# STAFF REPORT

**Case #19-14: SITE PLAN REVIEW**  
**Case #19-15: SPECIAL PERMIT**  
984 Sharon Street  
Map: 137A  
Lots: 21-25, & 33-37

Request by applicant for Site Plan approval for new construction of a three-story apartment building with 12 residential units; and for a Special Permit for a reduction of the number of parking spaces required for the apartment building; located at 984 Sharon Street (Map: 137A, Lot: 21) on a .74 ± acre site in a Mixed-Use Business [MUB] zoned district.

**Pavement conditions**

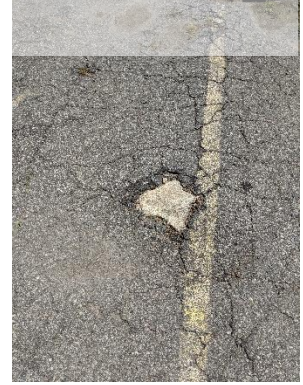
Staff note the existing pavement has alligator cracks and pot holes. Also, the asphalt curbing around the parking areas is broken in multiple places.

2. The parking lot area is to be resurfaced and restriped.
  3. Any pedestrian walkways or steps with damage that may be a hazard to pedestrians is to be repaired.

**Basketball area/rec area**  
(to be removed for added green space)

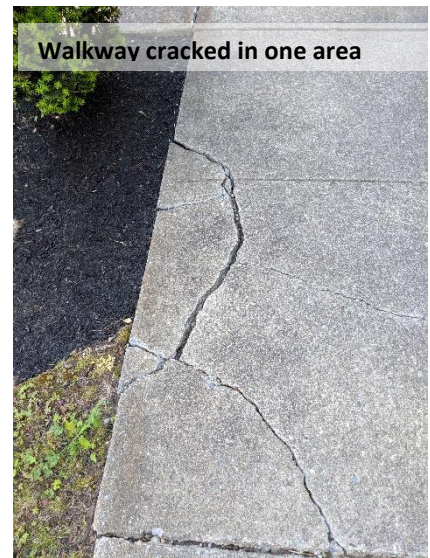
The proposal includes changes to the site plan including: saw-cutting and patching two sections of the existing parking lot to install roof recharge systems, and installing two others in the grassed landscaped areas on the west side of the building. Also, the paved area in the southeast corner of the site is to be removed and converted to green space.
